Berkeley Heights Environmental Commission

February 7, 2022

TO: Zoning Board and Township Engineer

RE: 725 Mountain Avenue, Block 32, Lot 2006

Bioretention System with Underdrain - Profile View

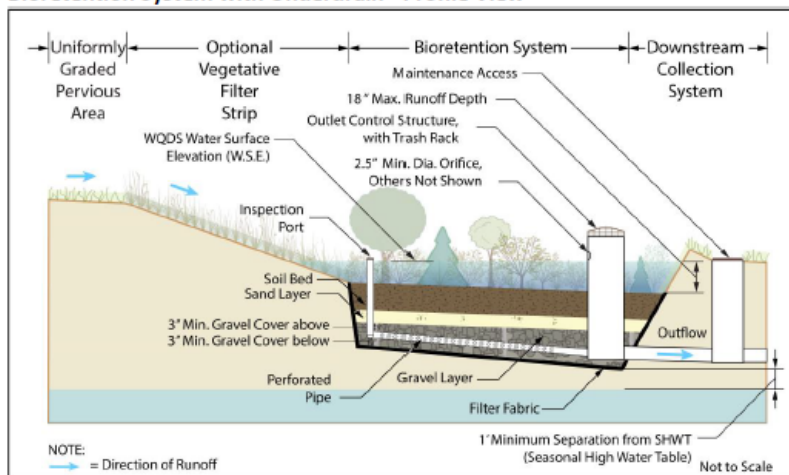
Could the bioretention basin be designed as shown below with filter fabric at the bottom? Chapter 9.1 also states:

- The bottom of a bioretention system must be as level as possible in order to allow runoff to uniformly infiltrate into the subsoil.
- The SHWT or bedrock must be at least 2 feet below the bottom of the soil bed.
-

Bioretention System Basics - Plan View

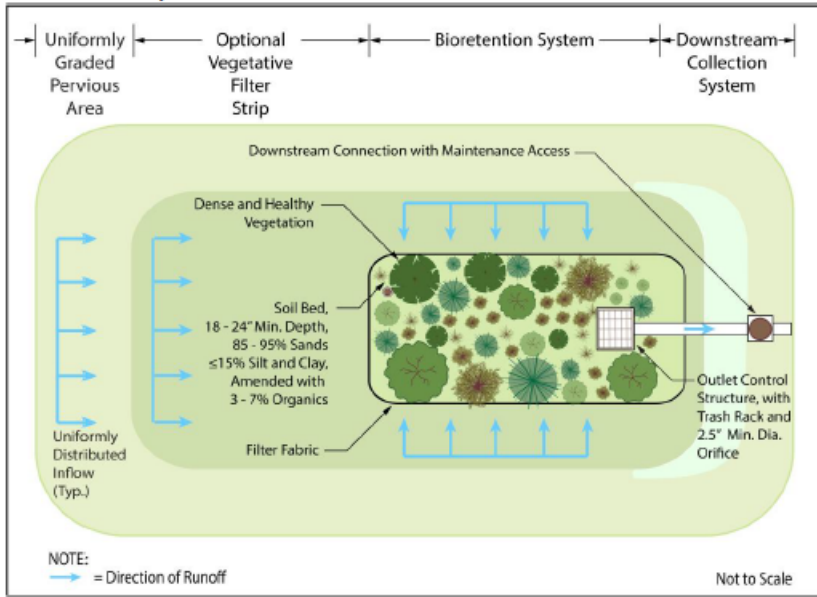
The Environmental Commission also recommends the construction of the bioretention basin include low maintenance landscaping, which encourages retention, and the planting of native vegetation, as suggested in the plan view below.
